Public Works Department – Engineering Division

**ADDENDUM NO. 1**

**PROJECT 3080 PITTSBURG PREMIER FIELDS**

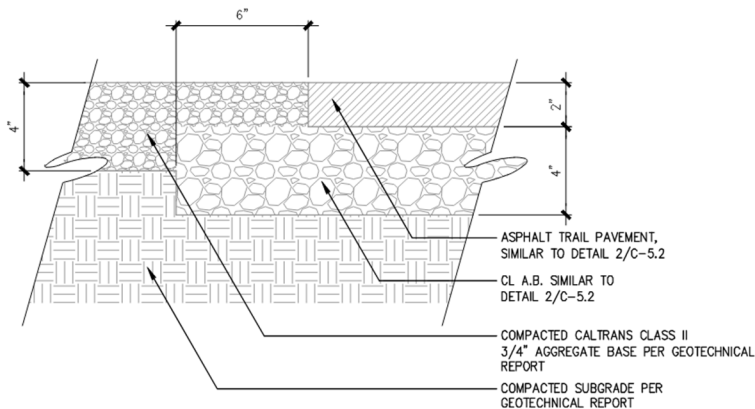
19. *Question:* Bid item 11 for Fine grading has a quantity of 265,262 sf. Bid item 48 for Hydroseed and Bid item 53 for Landscape Soil Preparation include fine grading. There isn't another 265,262 sf of area to fine grade on the project. Please confirm what is to be included in bid item 11 and if this quantity is correct.

*Answer: See revised Unit Price Description for Items 48 and 53 as Fine Grading has been removed from the description. All Fine Grading shall be paid for under Bid Item 11 and the quantity has been revised to 261,000 SF. As a result of this Bid Item 48 has been revised to 49,508 SF, see revised bid schedule.*

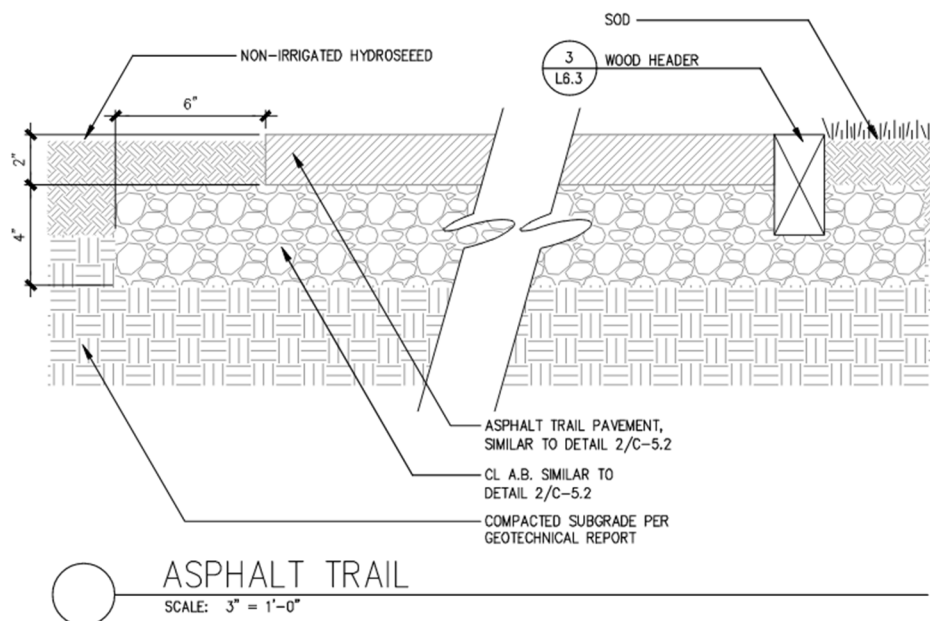
23. Please confirm that the asphalt pedestrian walkway structural section will be 3 ½” of hot mix asphalt over 12” of aggregate base.

*Answer: 2” over 4” per updated detail for Pedestrian Asphalt, see detail below. The detail will be added to the conform construction plan set.*
